THIRD READING SUMMARY SHEET

ZONING CASE NUMBER: C814-2015-0074

(The Grove at Shoal Creek Planned Unit Development)

ZONING CHANGE REVIEW SHEET

Figure 3.4.1: Bull Creek Road

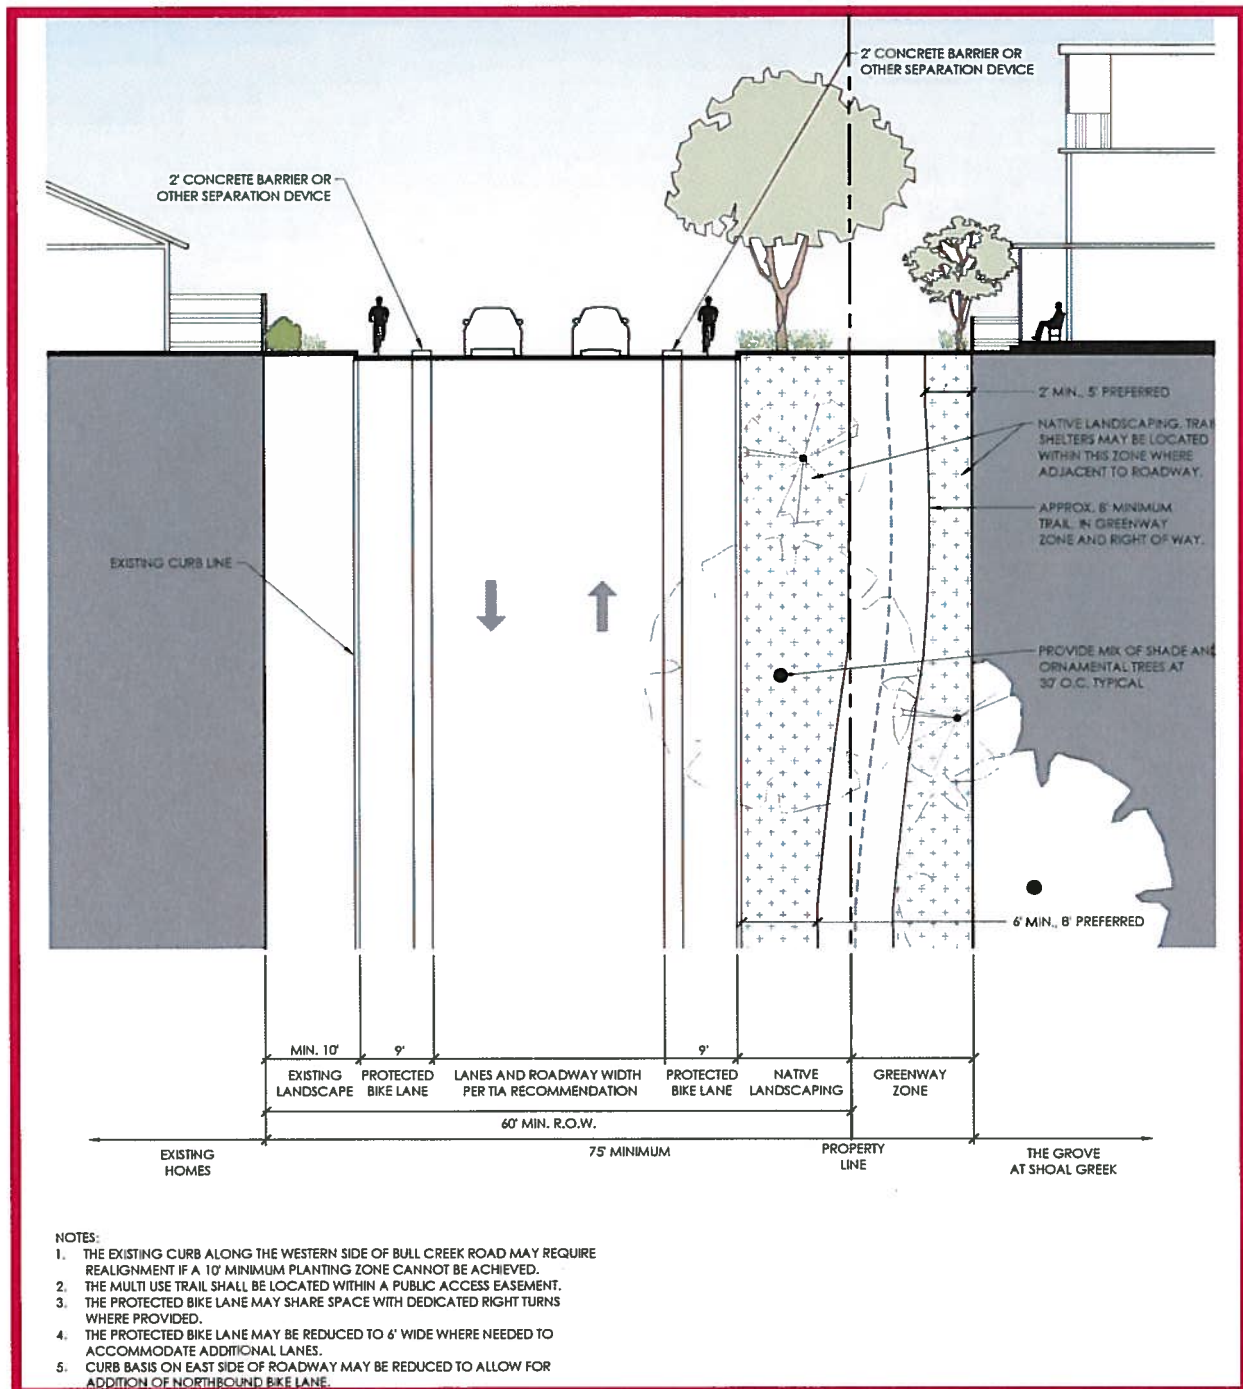
5. The Bull Creek Road section (Figure 3.4.1 on page 14) has been updated to include a northbound bike lane. *(ZAP Recommendation)*
6. The Retail Main Street section (Figure 3.4.2a on page 15) has been updated to allow for alternative parking configurations. *(Per meeting with City Staff on 8/9/16)*

Figure 5.1: PUD Parks Plan Exhibit

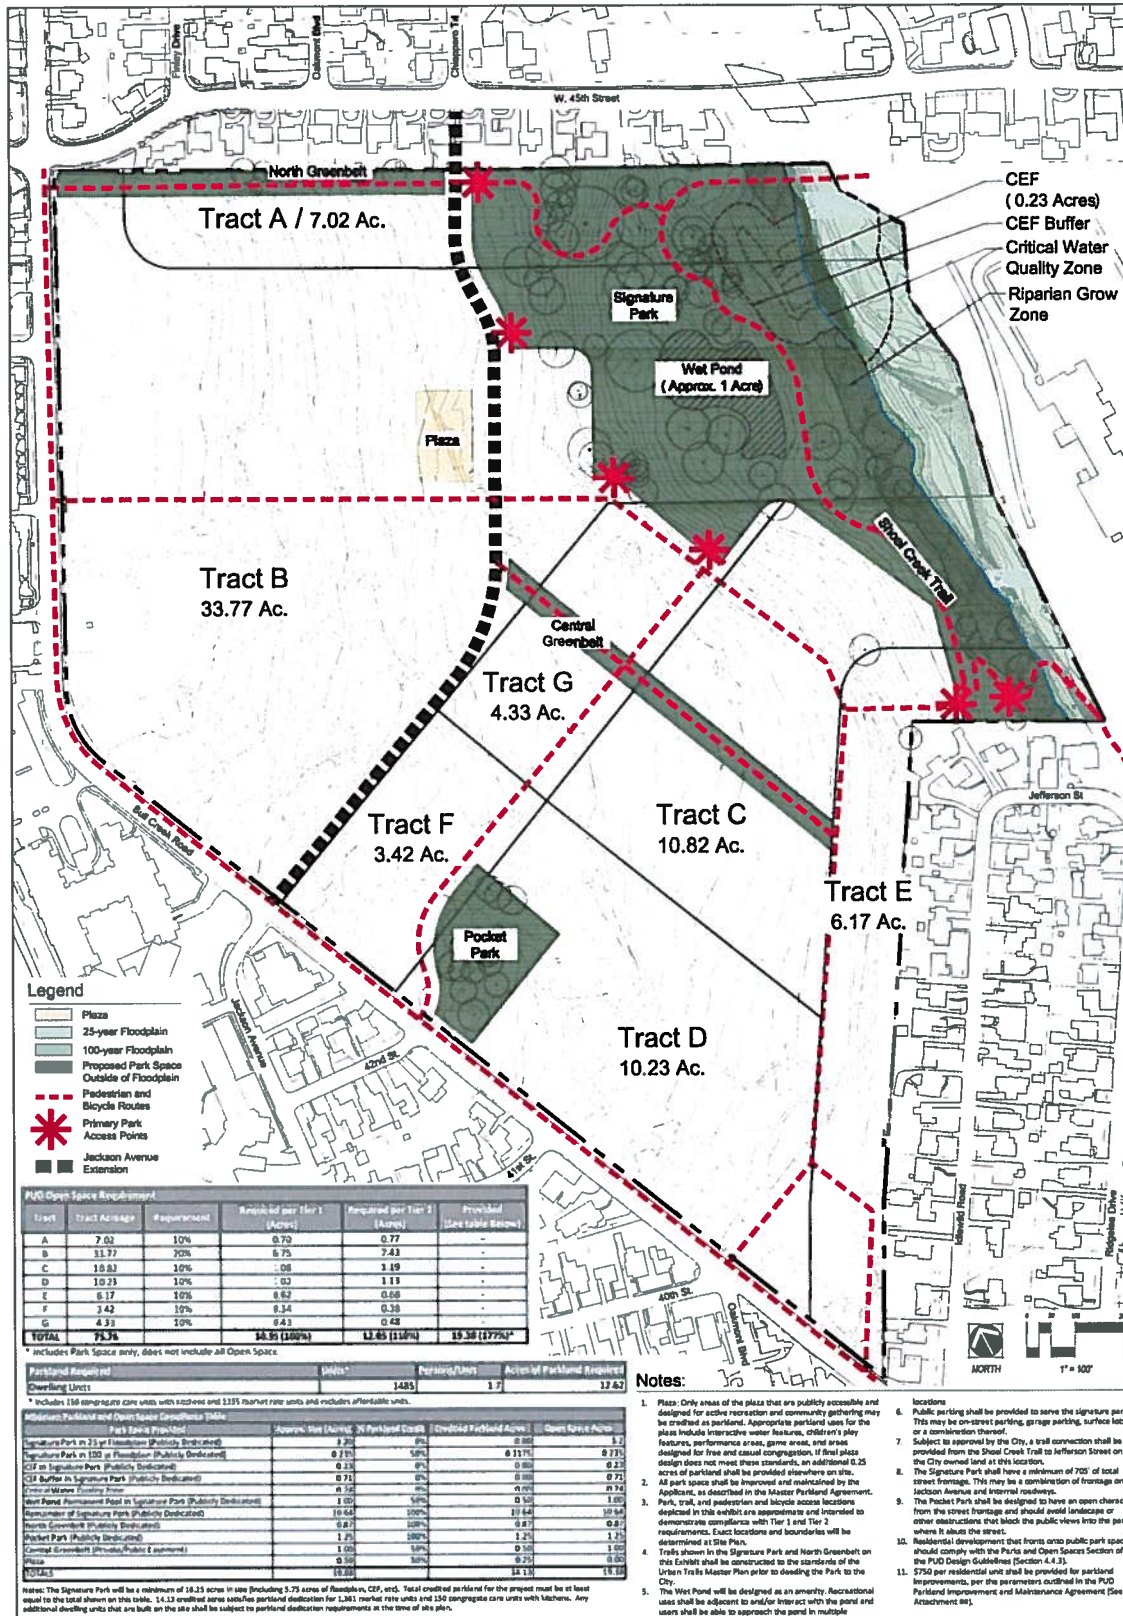
18. The Framework Plan on page 36 of the March 2016 document has been removed because it was redundant. *(Clarification)*
19. The PUD Parks Plan (Figure 5.1 on page 39) has been added to the document. *(Clarification)*
